PEARY STREET, MANCHESTER

Supplementary Transport Note

This technical note has been prepared in relation to planning application 139462/FO/2024, and specifically is intended to address a number of the queries raised by the local highway authority in their response to this planning consultation, with reference to the local highway authorities note dated 11.4.24 (received by WSP 24.4.24).

TITLE: Vehicle Tracking and Visibility Splay

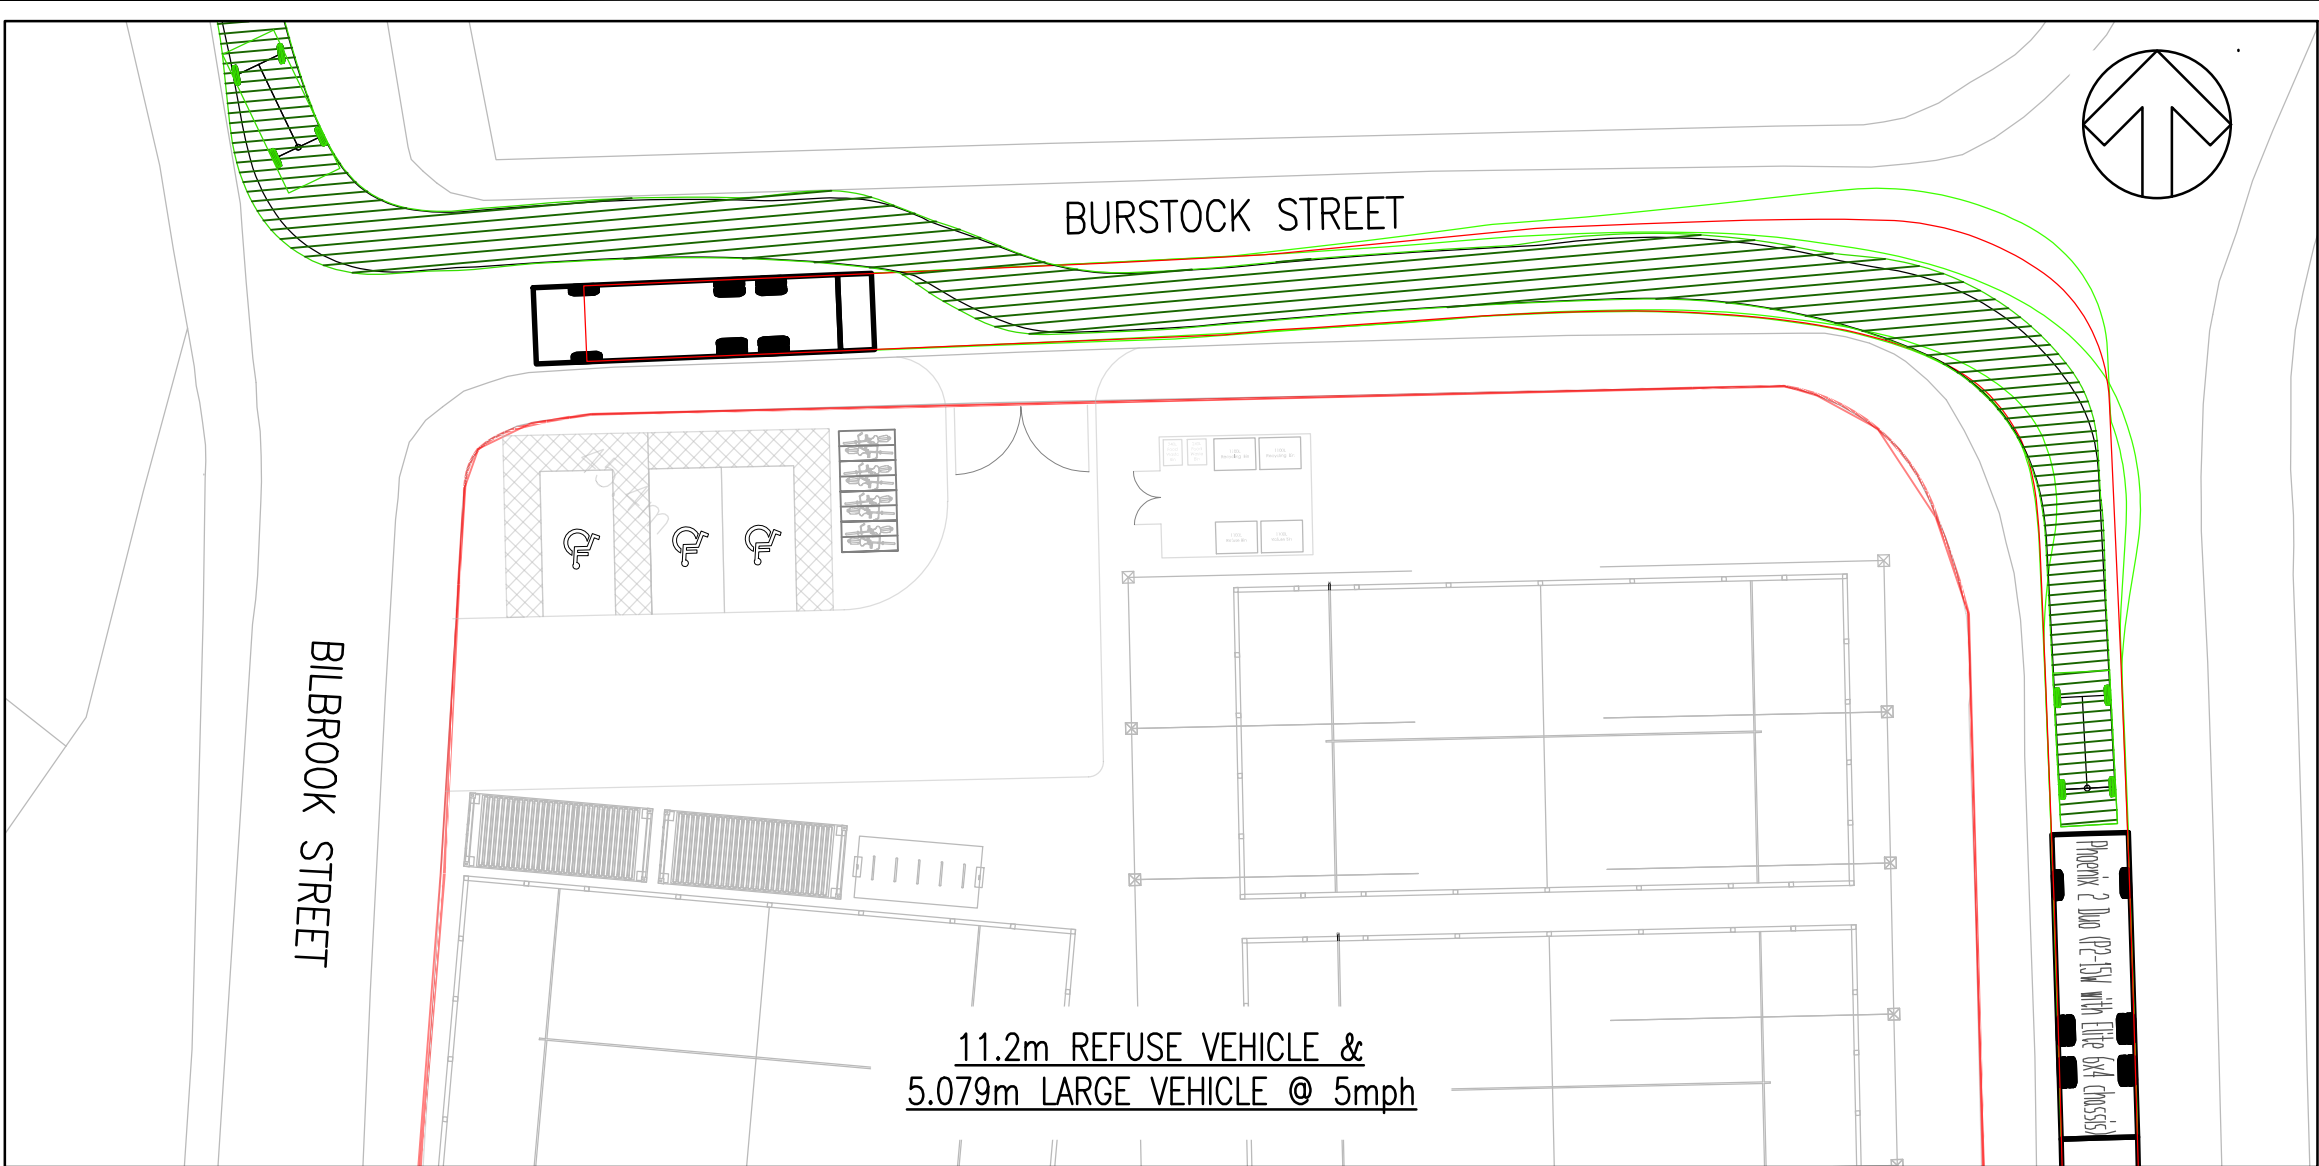
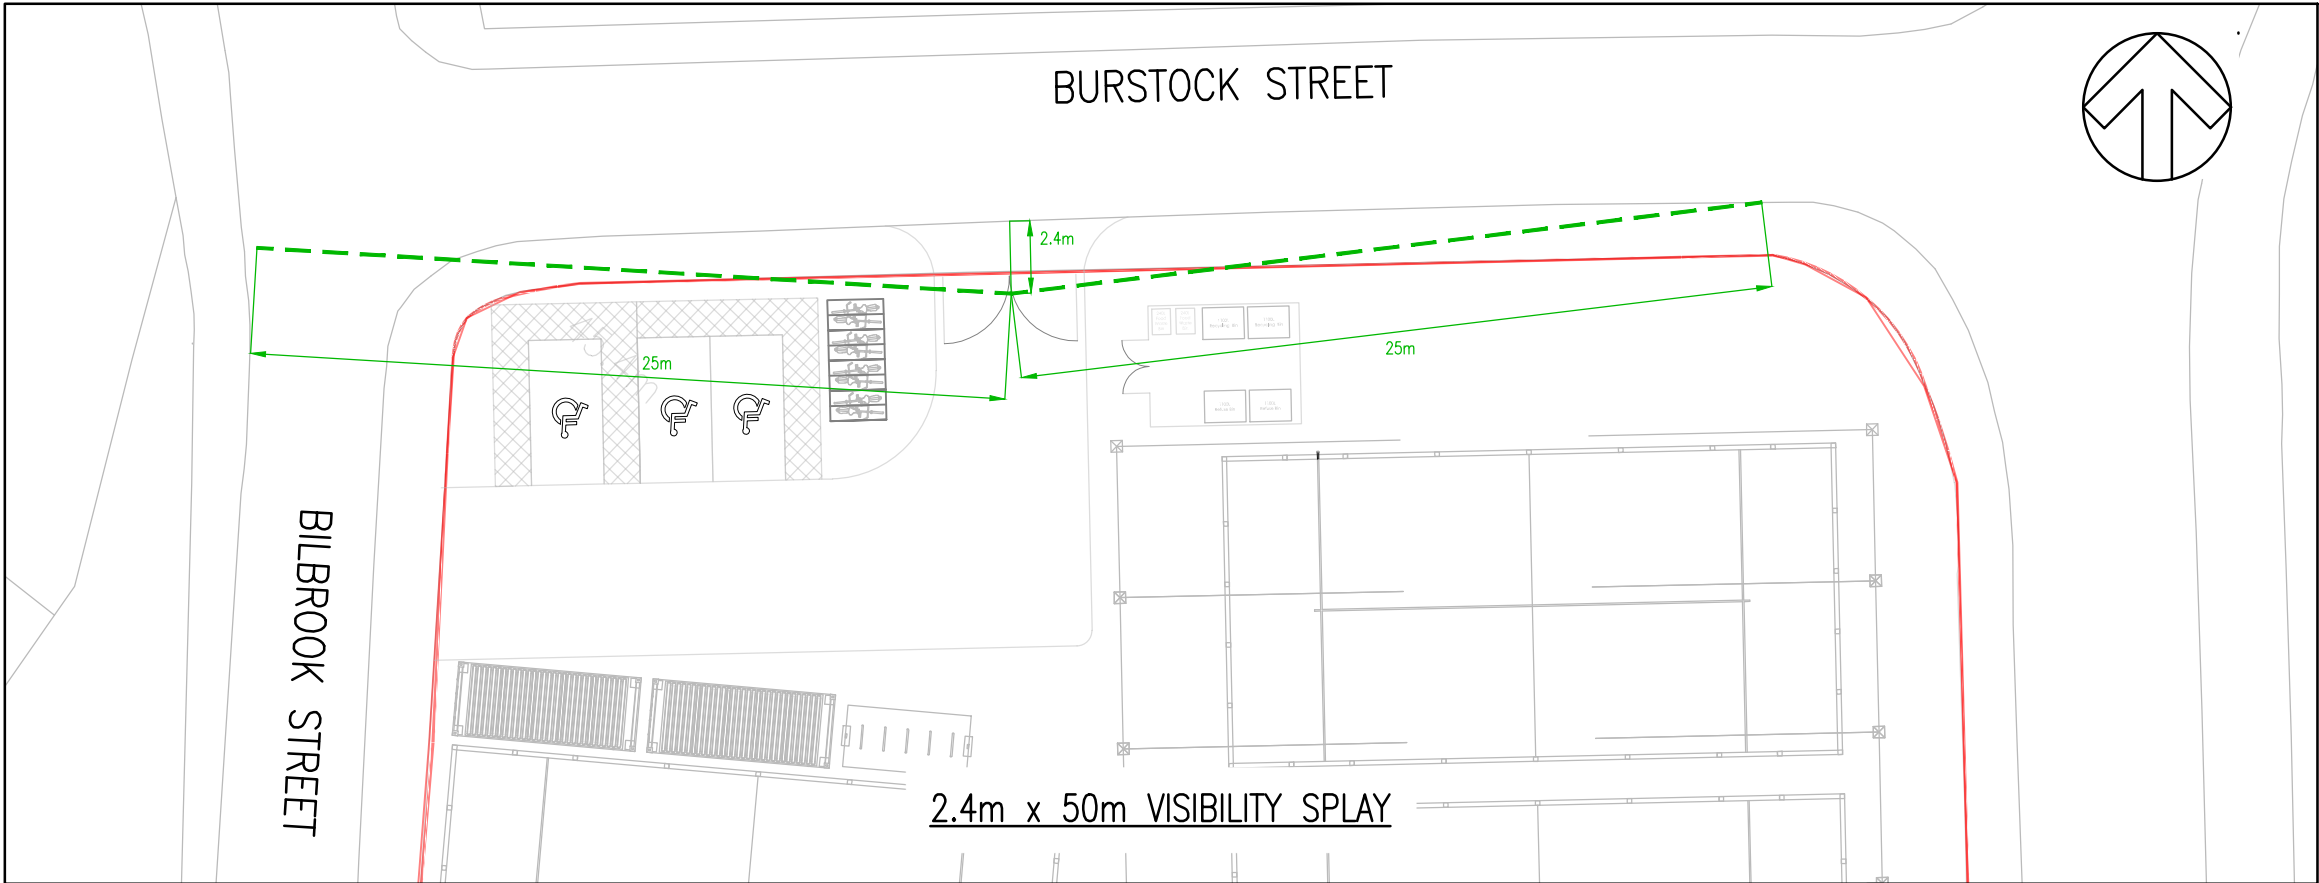
4	<i>A visibility splay assessment should also be provided in consideration of proposed boundary treatment and the bin store structure which is located close to the back of footway.</i>	Visibility splay assessment adopting 20mph design speed on Burstock Street is included within Appendix B.
5	<i>Highways request that a demarcated/dedicated pedestrian route into the site is provided from Burstock Street to reduce potential conflict between pedestrians and vehicles. An additional pedestrian access is also proposed from Back St George's Street.</i>	Given the very low level of traffic (i.e. access only to 3 accessible parking spaces) we consider the provision of a dedicated pedestrian route is excessive. We would further note that this will be a secondary pedestrian access, with the majority of footfall likely to arrive from the south via Back St Georges Road.
6	<i>All existing points of vehicular access will be closed/gated. Highways would request that any subsequent applications at this site would require footway reinstatement at these redundant points together with dropped-kerbs and tactile paving at the site access points and within the local vicinity.</i>	Noted and agreed.

security through being overlooked by regular pedestrian footfall from site users and staff.
16	TRAVEL PLAN: <i>A Framework Travel Plan has been provided. Highways request that a Full Travel Plan is conditioned with any approval.</i>	Noted and agreed, we suggest this is a post-opening condition which will allow for staff and visitor travel habits to be surveyed.
17	DELIVERIES & SERVICING: <i>Waste collection would take place from Burstock Street, with vehicles stopping on the highway in close proximity of the bin store. A swept-path assessment has been submitted which demonstrates that Burstock Street can accommodate such movements and that existing traffic flows would not be affected (subject to appropriate TRO provision). The plans appended within the TS however do not appear to show the Burstock Street site access.</i>	Please see updated tracking drawing at Appendix B, which is based upon the latest site layout.
